# Access Compliance Report

## Public Rights-of-Way

### (Curb Ramps)

Intersection ID: 3299	Main Street: BRANTHURST_DR	Cross Street: SPRING_PARK_DR	Location: W
ADA ID: EB10B6D9683A	Ramp Type: Perp	Initial Pass/Fail: Fail	Overall Compliance: No
Severity Score: 30			
Codes/Mitigation Info/Possible Solution		Field Measurements/Component Compliance

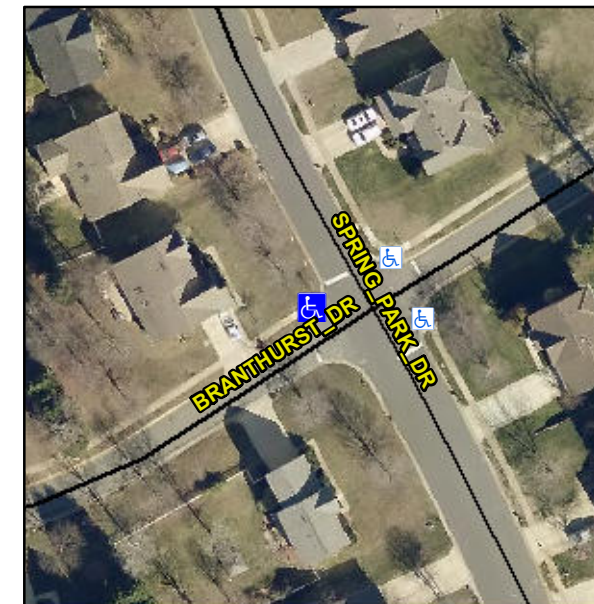
Surveyor Notes:

**N/A**

PROW/ADA:

**R304.5.1, R304.5.3**

Compliance	Description	Data	Compliance	Description	Data
N/A	Ramp Length (in)	96.0	Yes	Ramp Slope (%)	6.2
No	Ramp Width (in)	35.0	No	Ramp XSlope (%)	6.6
N/A	Flare Type LT	N/A	N/A	Flare Type RT	N/A
N/A	Flare Slope LT (%)	N/A	N/A	Flare Slope RT (%)	N/A
N/A	Flare Traversable LT?	N/A	N/A	Flare Traversable RT?	N/A
N/A	Landing Length (in)	N/A	N/A	DWS Provided?	N/A
N/A	Landing Width (in)	N/A	N/A	DWS Contrast?	N/A
N/A	Landing Slope (%)	N/A	N/A	DWS Length (in)	N/A
N/A	Landing X Slope (%)	N/A	N/A	DWS Full Width?	N/A
N/A	Landing Curb? (Y/N)	N/A	N/A	DWS Offset (in)	N/A
N/A	Shared Landing?	N/A			
N/A	Gutter Ponding?	N/A	N/A	Gutter Slope (%)	N/A
N/A	Gutter Lip Ht (in)	N/A	N/A	Gutter X Slope (%)	N/A
N/A	Painted X Walk1?	No	N/A	Painted X Walk2?	N/A
	X Walk 1 Direction	To NE		X Walk 2 Direction	N/A
N/A	X Walk 1 Width (in)	N/A	N/A	X Walk 2 Width (in)	N/A
	X Walk 1 Slope (%)	4.9		X Walk 2 Slope (%)	N/A
	X Walk 1 X Slope (%)	3.1		X Walk 2 X Slope (%)	N/A

N/A	Ramp inside XWalk1?	N/A	N/A	Ramp inside XWalk2?	N/A
	Road Slope (%)	N/A	N/A	Clear Space?	N/A
	Road X Slope (%)	N/A	N/A	Clear Space to XWalk (in)	N/A
N/A	Any Obstructions?	N/A	N/A	Storm Grate/Utility Hazard?	N/A
	Obstruction Type			Storm Grate/Utility Type	
		N/A			N/A
			Yes	Surface Condition? (G/P)	Good

Possible Solutions:

**Remove & Replace Entire Ramp.**
